**SB-52
Terminating Awning Wires on 2016 45OP Allegro Buses
With 2nd Paramount Awning Option**

Instruction Number: Service Bulletin 52 (WI-297)

Purpose: To provide instructions on how to Properly Terminate Awning Wires for All Bus and Zephyr with 2nd Paramount Awning Option

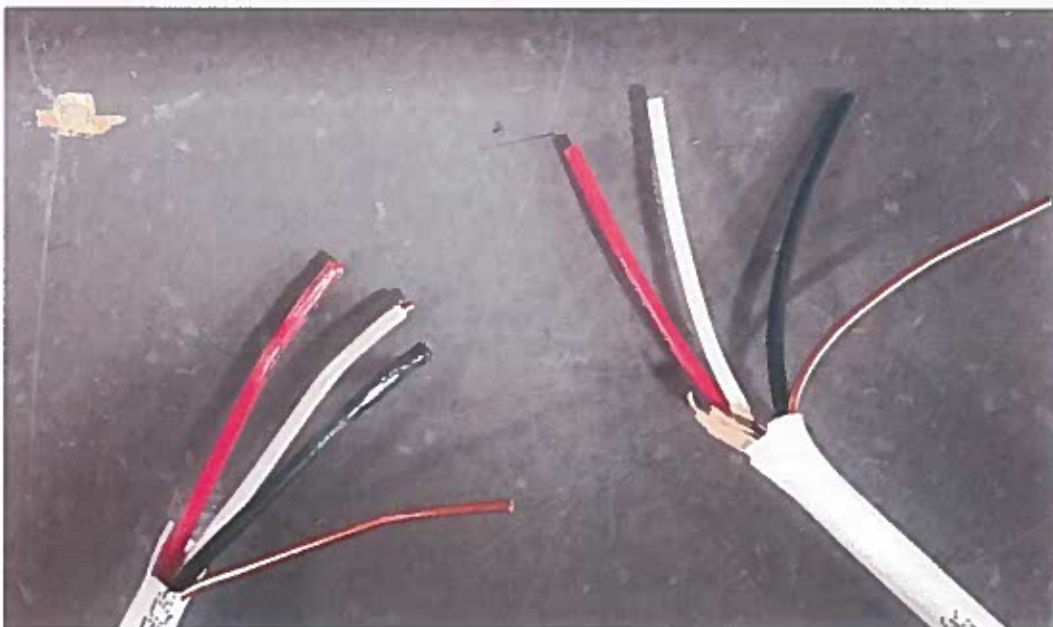
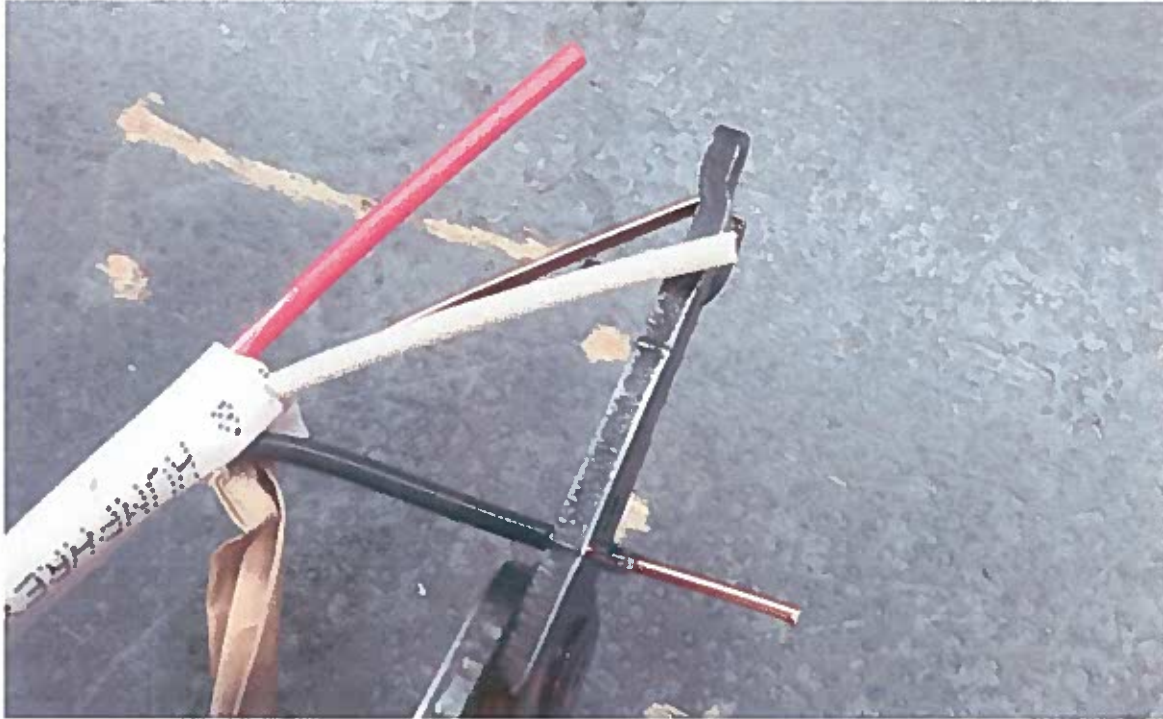
3. Find two 110V 14/3 with ground Romex wires (The Insolation will be white) made up of two black, two red, two white and two ground wires. They are connected together by wire nuts and likely taped together by electrical tape. The connection should be less than a foot from the panel you removed in the previous step.
4. Remove the wire tape and wire nuts one at a time as to prevent the copper from touching anything.
5. Using insulated wire cutters remove all exposed copper on all the wires except the ground wire.

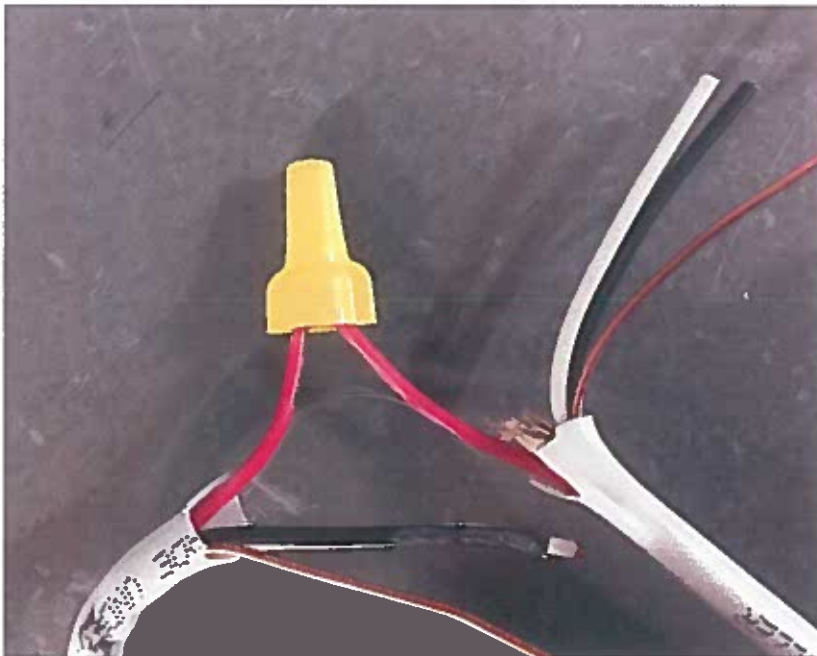
6. Insert the wires into the JUNCTION BOX 8 CU 1 GNG SIDE MOUNT

7. For one color, use wire strippers to remove the insulation. There should be a maximum of ½" exposed copper on the end of the wire. Make the connection to the color you started with prior to stripping any wires of another color.

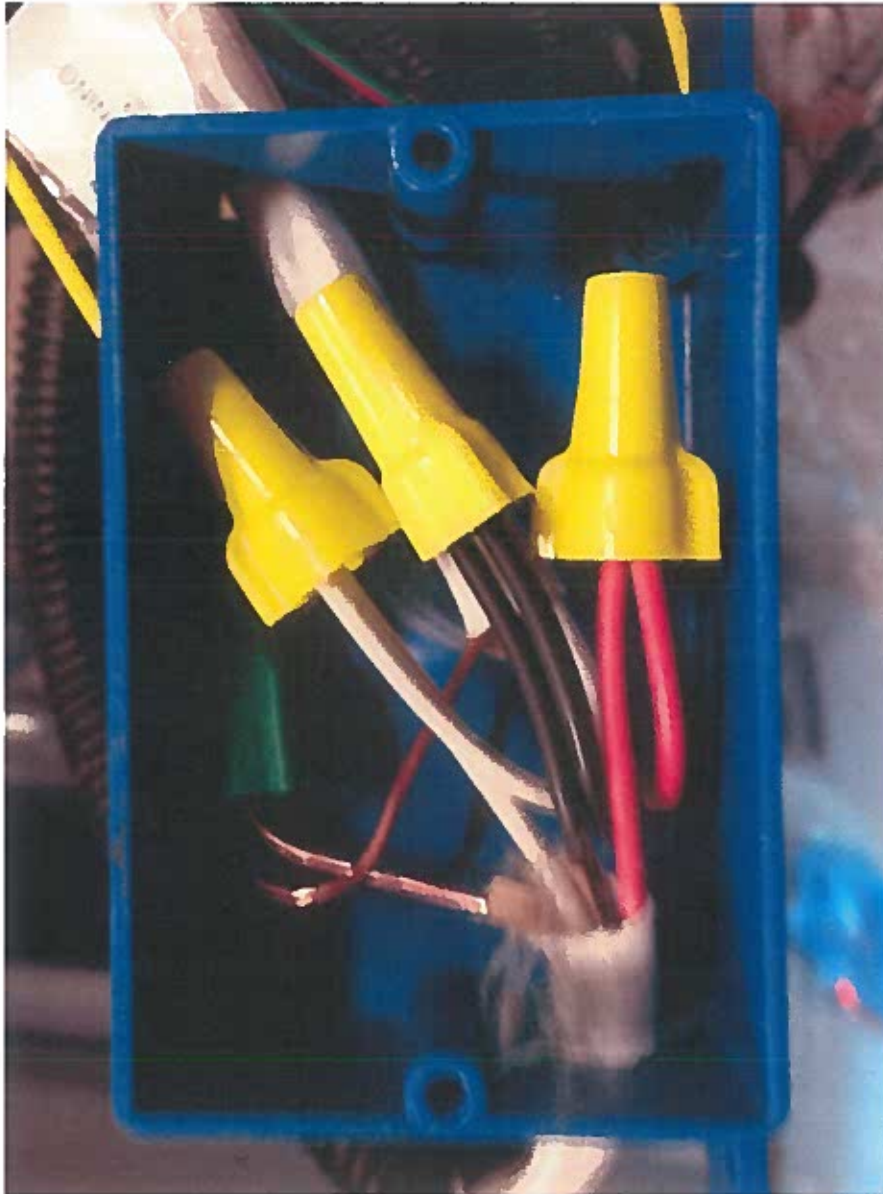
- Using a wire nut secure the wires together. Note: Connections must be made Red to Red, White to White, Black to Black, and Ground to Ground. Make sure there is no copper visible on any connections with the exception of the ground wire.

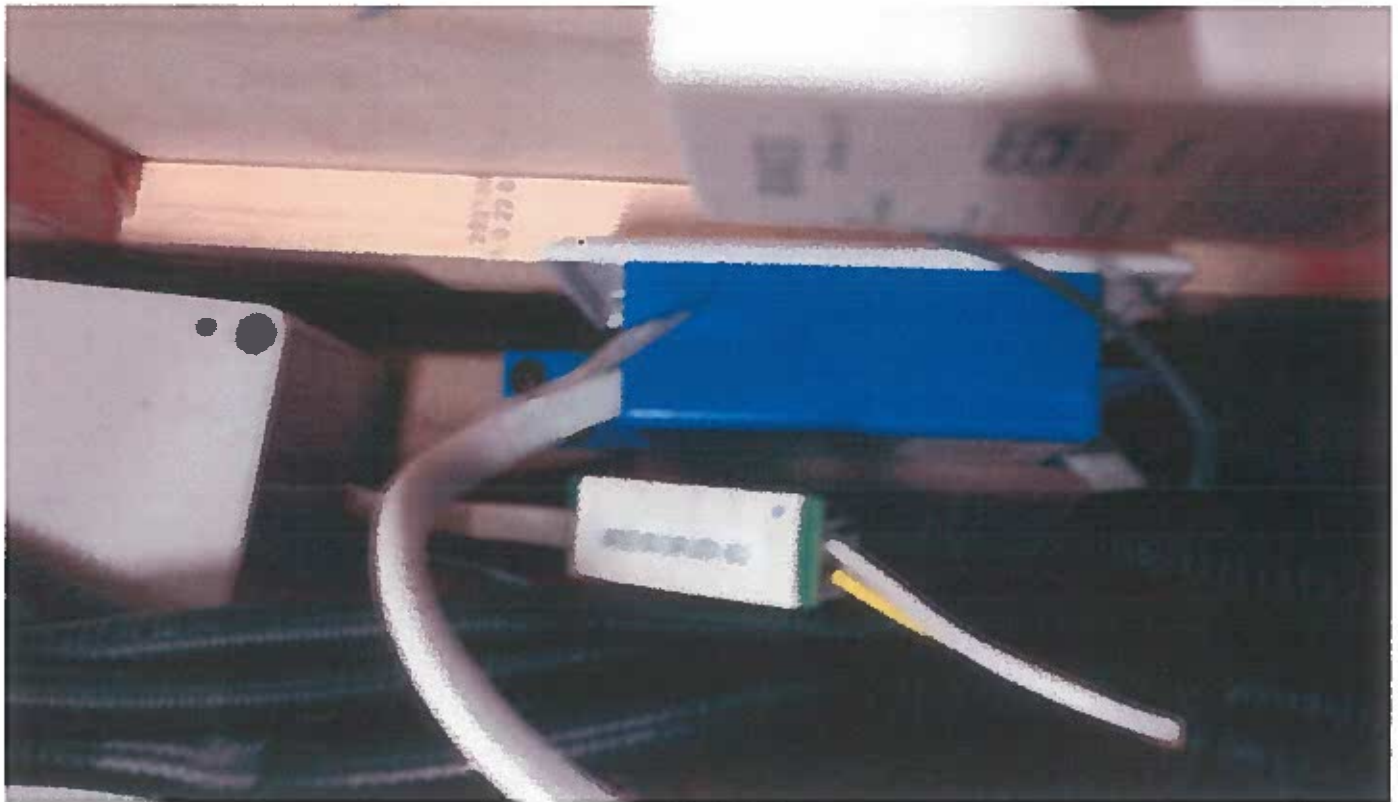
9. Using a flat head screwdriver secure the PLATE BLANK 1 GNG WH SCR ON to the JUNCTION BOX 8 CU 1 GNG SIDE MOUNT.
10. Attach the JUNCTION BOX 8 CU 1 GNG SIDE MOUNT to the wood as seen below, using four 3/4X1 1/2X17 1/2 SPF Screws.
